SCHEME FOR MCC 5A
SEAFORTH GRAIN TERMINAL

CTX 361 AD

TITLE —
SCHEME FOR MCC 5A — SEAFORTH GRAIN TERMINAL

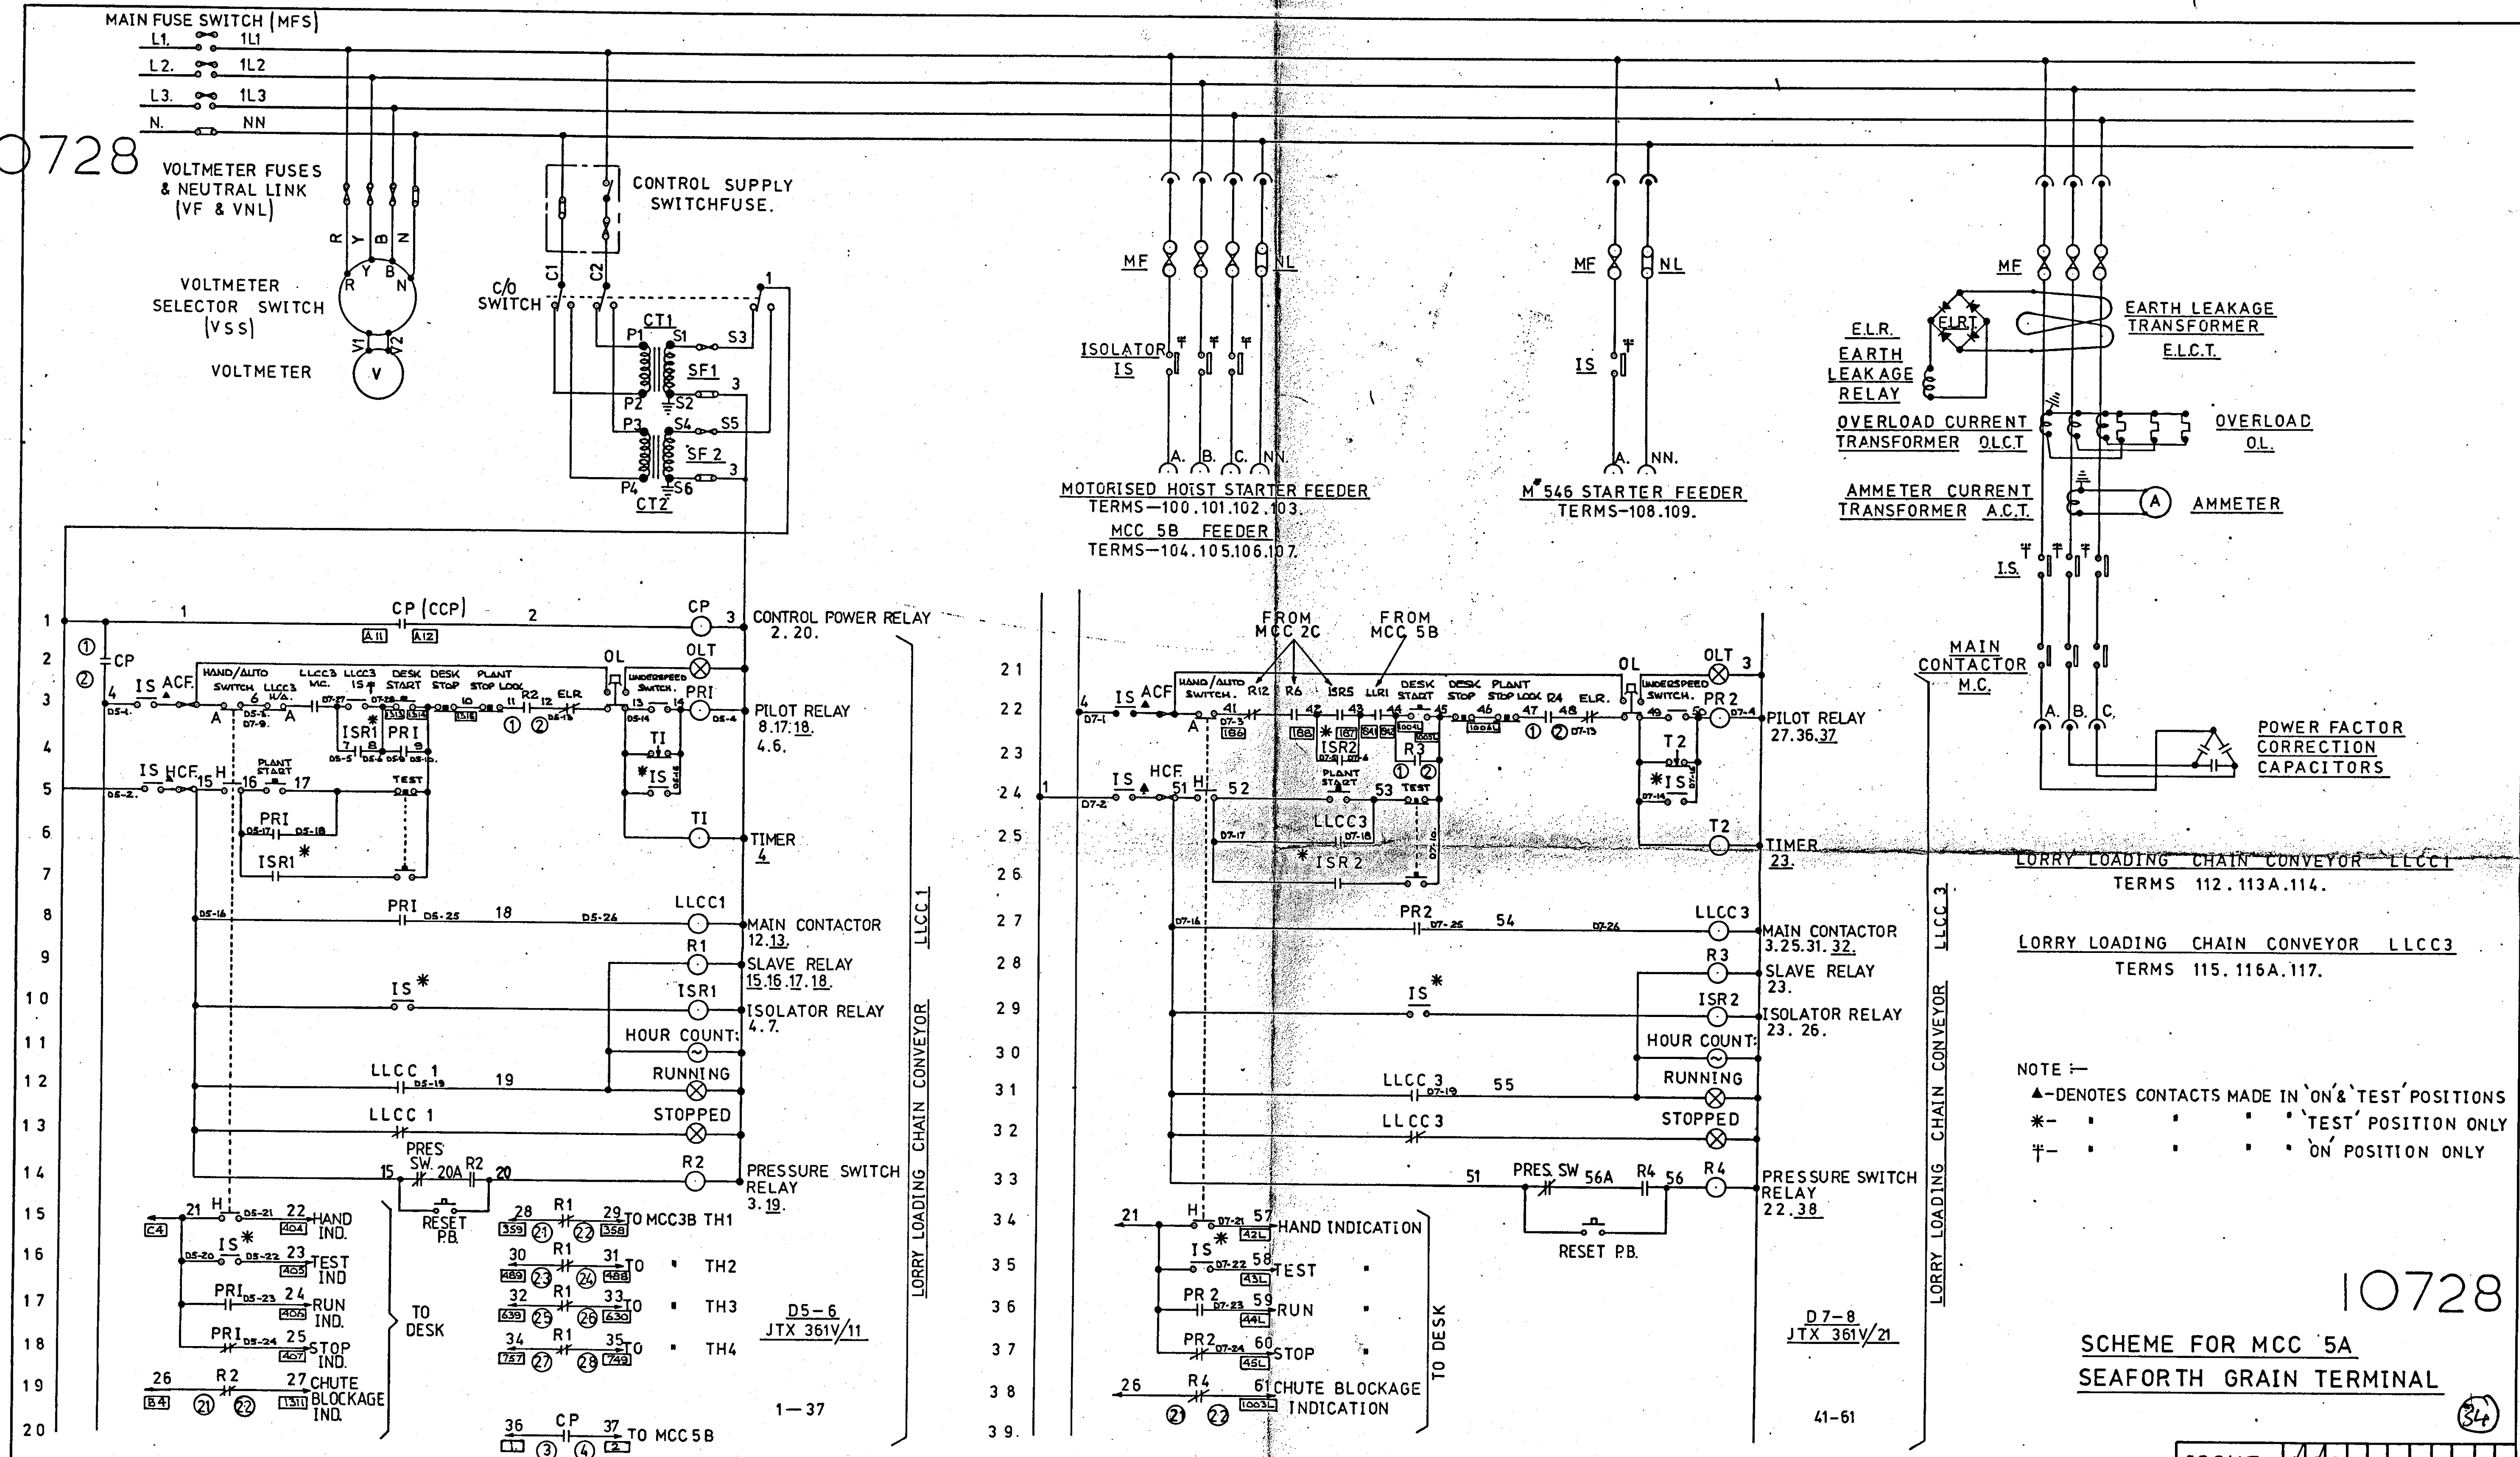
REVISION 3	REVISION 2
Line 14: R2 contact	R1 & R2 WERE
& reset PB added	ACROSS MAIN
Line 33: R4 contact	CONT; COILS
& reset PB added	27-5-71
14-7-81 R.H.N.

REVISION 1
LLCC.1. SUSTAINING
CONTACTS WERE
ON MC
20-4-71
